CHRYSLER A500 (42RE) SERIES NEW DESIGN DIRECT CLUTCH HOUSING

01-11 Page 1 of 4

Figure 1
AUTOMATIC TRANSMISSION SERVICE GROUP

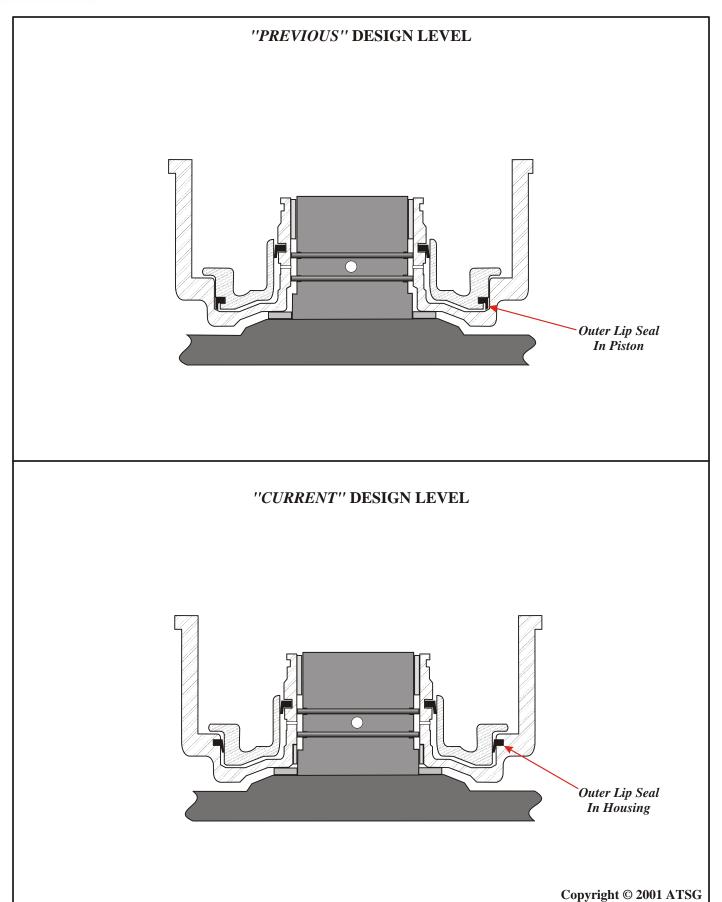
CHANGE: Chrysler Corporation re-designed the Direct Clutch Housing on the A500 (42RE) transmission, during the 98-99 model years, on some models only. This clutch is applied in 3rd gear and reverse. Refer to Figure 1 for cut-away illustrations af both previous and current design housings.

- (1) DIRECT CLUTCH HOUSING Now is manufactured with the outer lip seal groove in the clutch housing instead of the clutch piston. Also the addition of another bushing in the clutch housing to support the clutch housing when installed on the pump cover, and addition of "V" shaped grooves where the steel plates and pressure plate ride in drum, as shown in Figure 2.
- (2) DIRECT CLUTCH OUTER SEAL Now an inside lip design, to accommodate the changes in the clutch housing, as shown in Figure 2.
- (3) DIRECT CLUTCH PISTON Now manufactured *without* the seal groove in the piston to accommodate the new seal in the housing, as shown in Figure 2.
- (4) DIRECT CLUTCH PRESSURE PLATE Now manufactured with two of the locating tabs missing, and must be oriented properly to fit into the clutch housing because of the added "V" shaped grooves, as shown in Figure 3.

Figure 2
AUTOMATIC TRANSMISSION SERVICE GROUP

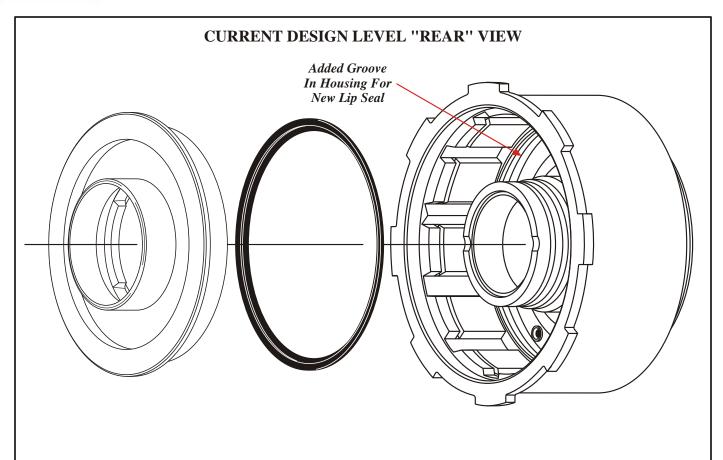
CURRENT DESIGN LEVEL "FRONT" VIEW Improved Feed Passage To Inner Lip Seal Copyright © 2001 ATSG
